## STAFF REPORT

**REFERENCE:** RM090634 (Subdivision), RM090635 (Land Use)

**SUBJECT:** **M and R STEPHENS - REPORT EP10/01/01** - Report prepared for hearing of 13 January 2010

**Figure 2** raised traffic Island/with a pedestrian refuge.

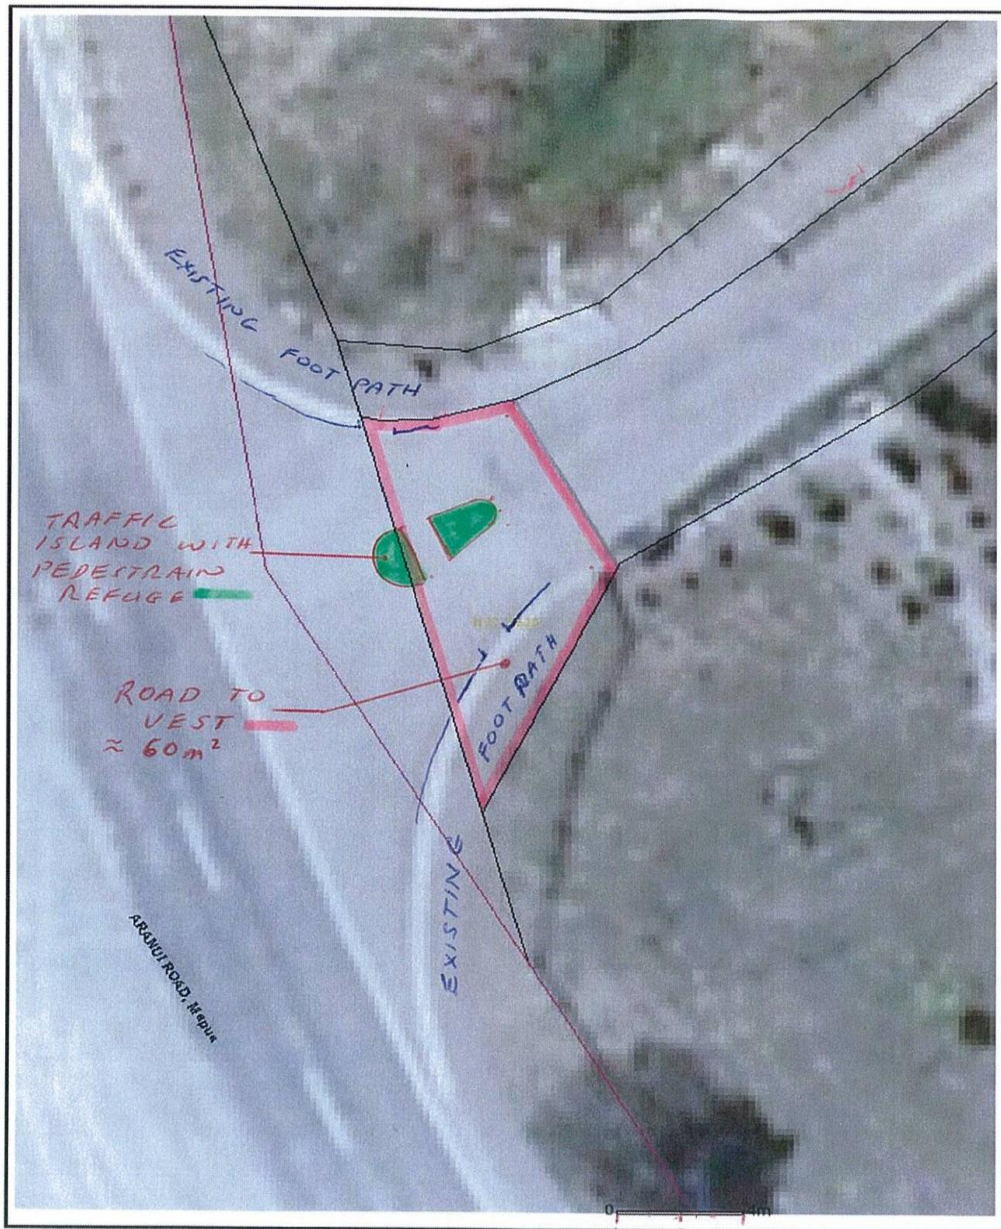
This can be achieved via vesting an area of approx 60 m<sup>2</sup> as road and the formation of a raised traffic Island/with a pedestrian refuge. (see attached marked up labelled figure 2)

Summary Vest an area of approx 60 m<sup>2</sup> at the Aranui end of the ROW  
Form a raised traffic Island/pedestrian refuge as shown on the attached concept plan and pram crossings.  
First section of ROW– 340 metres, existing seal – no work required.
